Homes at Meadow
Woods

Re: MEADOW WOODS off Stuart St.

Revised Final Plan Submission of Homes at Meadow Woods

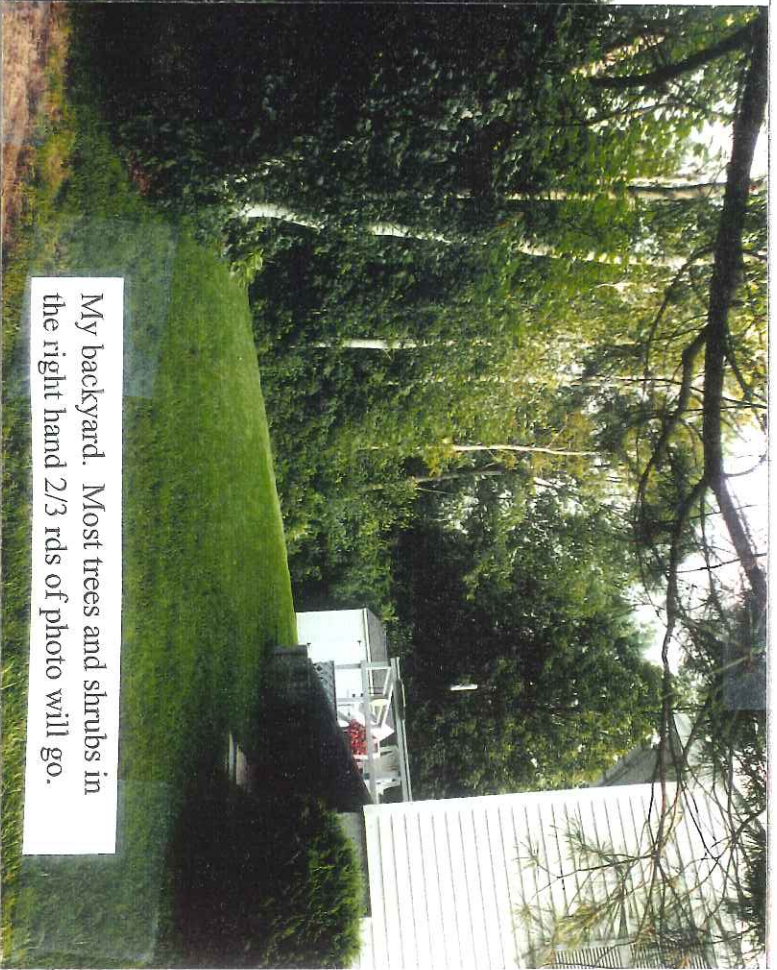
My house - The vacant lot at right will be the entrance to project. Most of the trees behind home and at right will be removed under the current plan.

My backyard. Most trees and shrubs in the right hand 2/3 rds of photo will go.

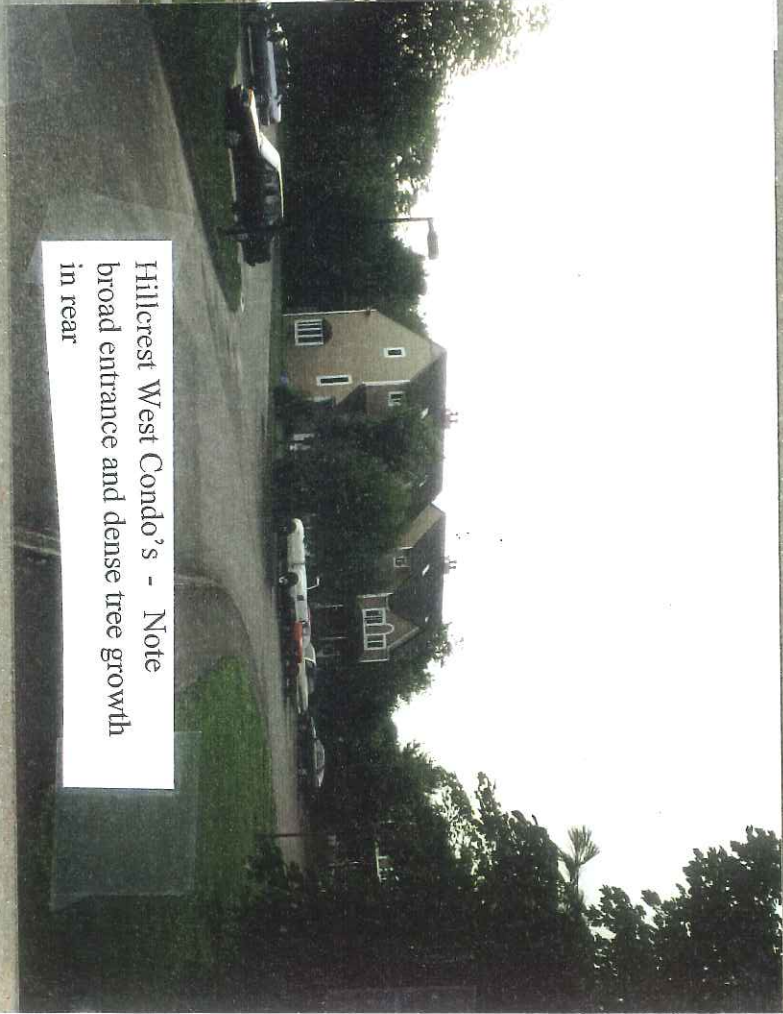
Looking down Stuart St., a very pleasant neighborhood - Most trees behind homes at right will go and be replaced with a stockade fence

Hillcrest West Condo's - Note broad entrance and dense tree growth in rear

Meadow Woods Entrance Sign Example

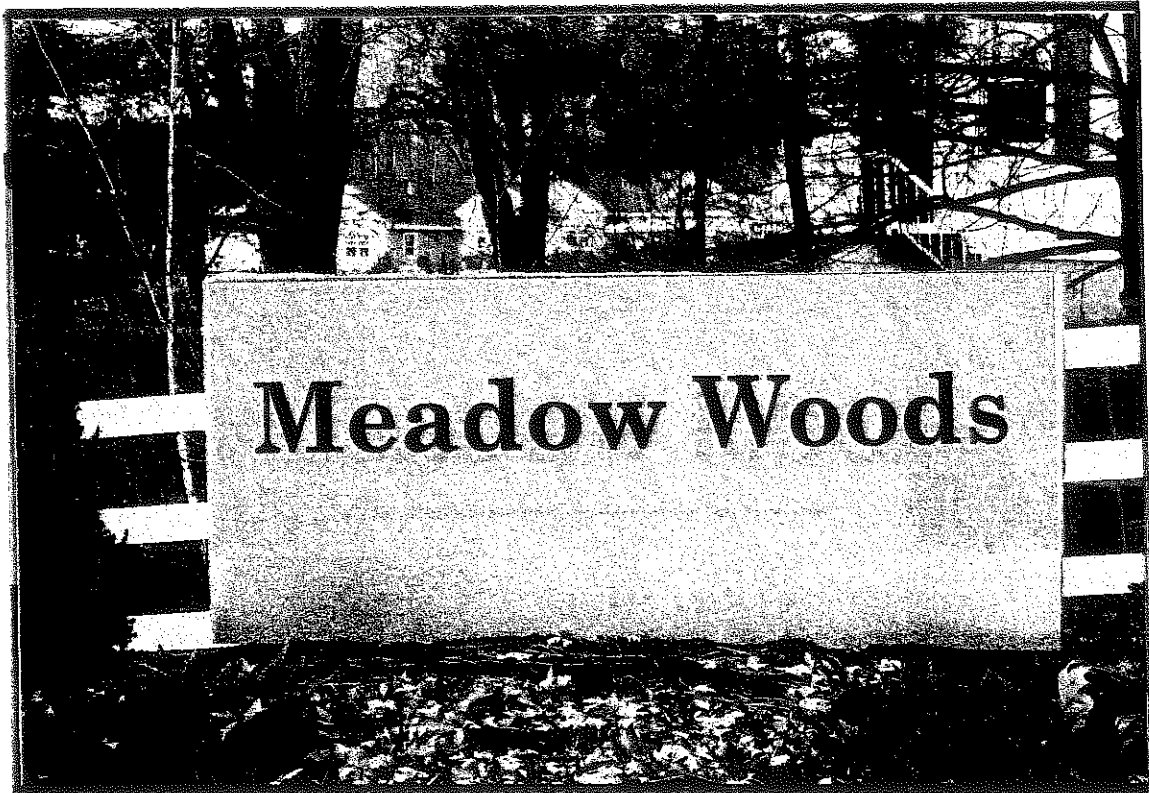
This is an example of the proposed entrance sign. We are proposing a granite entrance sign on the side of the entrance as shown on the plans. Our sign may have a small graphic added to the sign.
